Re: Case No. 14402: Application of Chevron U.S.A. Inc. for amendment of Division Order No. R-4442, as amended, to revise the injection well completion requirements and to change the basis for the calculation of the authorized injection pressure for carbon dioxide from surface pressure to the average reservoir pressure in its previously approved tertiary recovery project in the Vacuum Grayburg-San Andres Pressure Maintenance Project, Lea County, New Mexico.

REQUEST TO RETURN WELL TO INJECTION

**PROPOSED
WELLBORE DIAGRAM**

RE: Vacuum Grayburg San Andres Unit No. 30

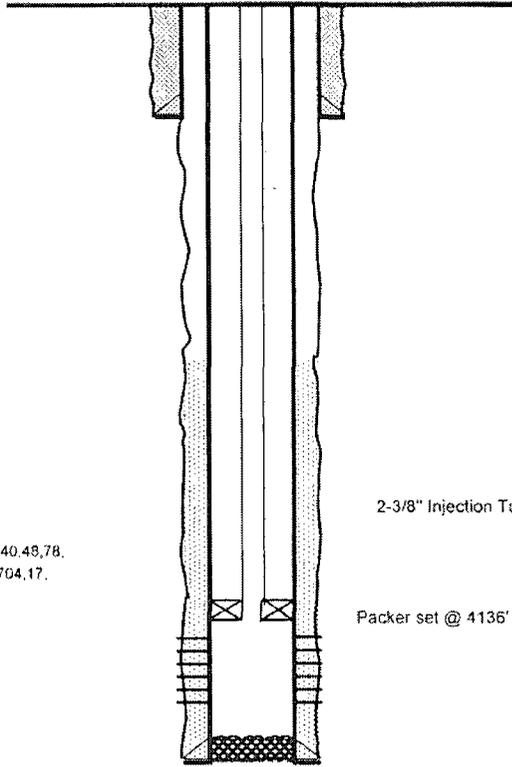
Chevron USA, respectfully requests administrative approval to set the injection packer at 4,136' in the subject well. Setting the packer at this depth will place the packer 307' above the top perforation. The last approved MIT test dated 12/08/01 C-103 reported the packer depth at 4,191'. The subject well is perforated from 4,443' to 4,740'.

Setting the packer at this depth is necessary as 28 years of water injection has deteriorated the casing to the point that a sufficient packer seat within 100' of the top perforation cannot be found. Based on log analysis, the top of the unitized interval is at 4,109'. Setting the packer at the requested depth will place the packer 27' below the top of the unitized interval.
